S E R V I C E N O T E

HP 4145B Semiconductor Parameter Analyzer

SMU Board Modification

Figure 1. A Current Measurement Example

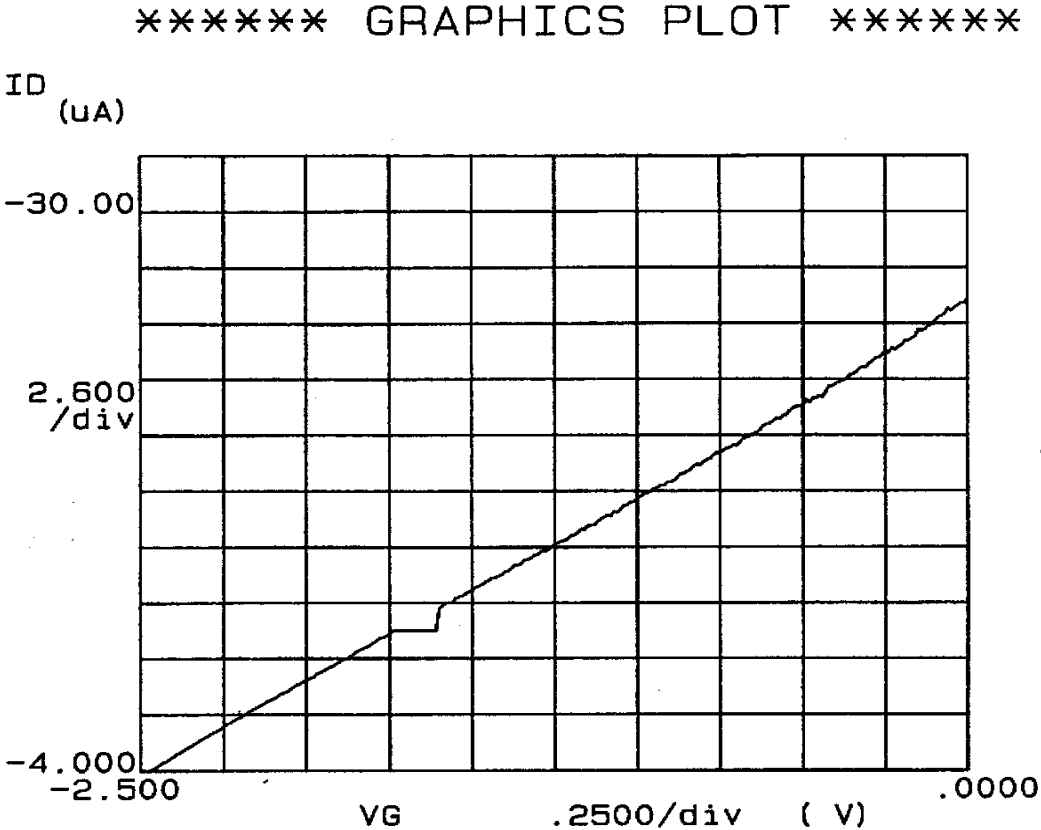
When measuring currents, an SMU may generate a dip spike, if a range change occurs. Figure 1 shows an example of this occurrence.

Figure 2. Location of A5CR11, A5CR15, A5CR18 and A5C419

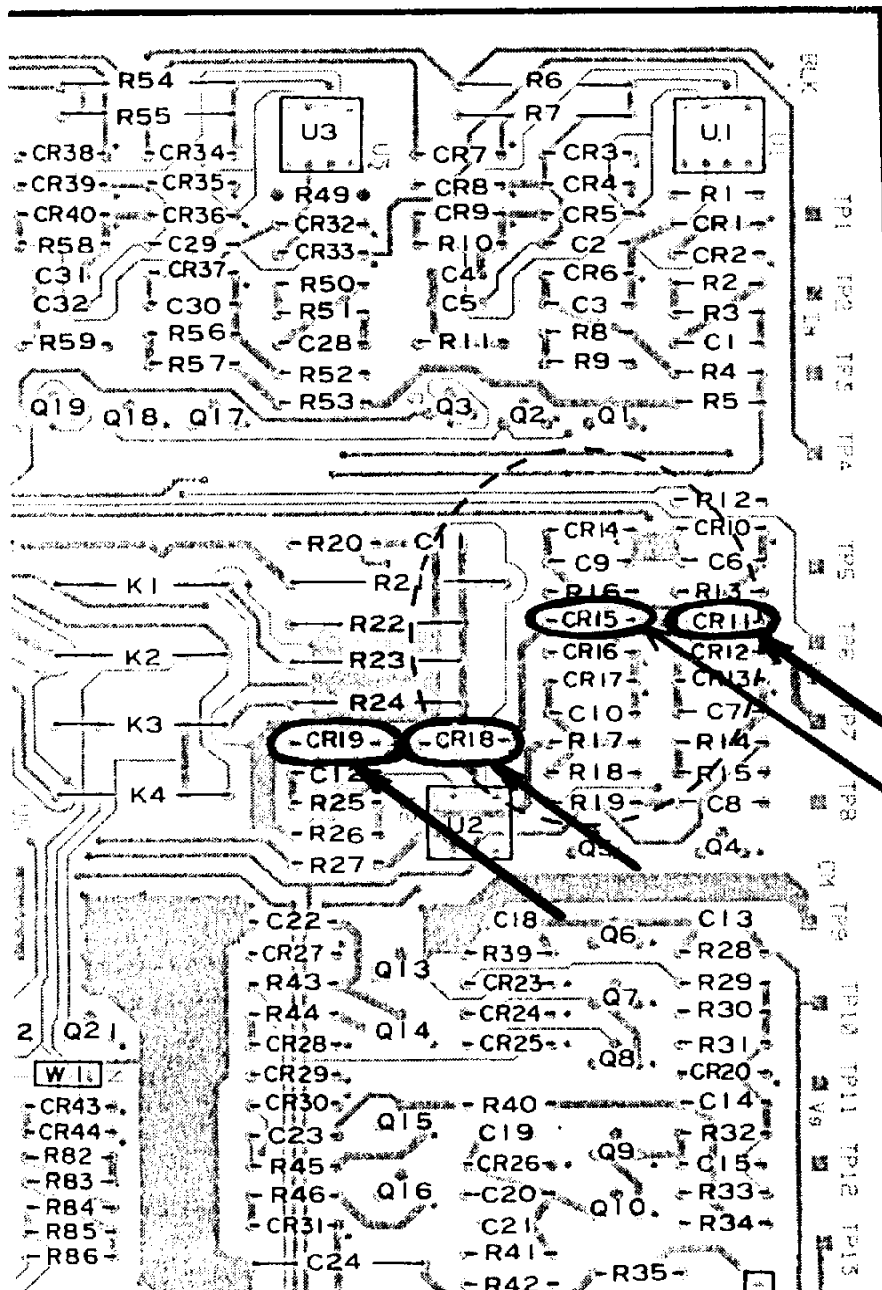
Replace diodes A5CR11, A5CR15, A5CR18, and A5CR19 with new diodes (HP P/N 1901-1380). Figure 2 shows location of A5CR11, A5CR15, A5CR18, and A5CR19.

After replacement, performance verification and adjustments are required.
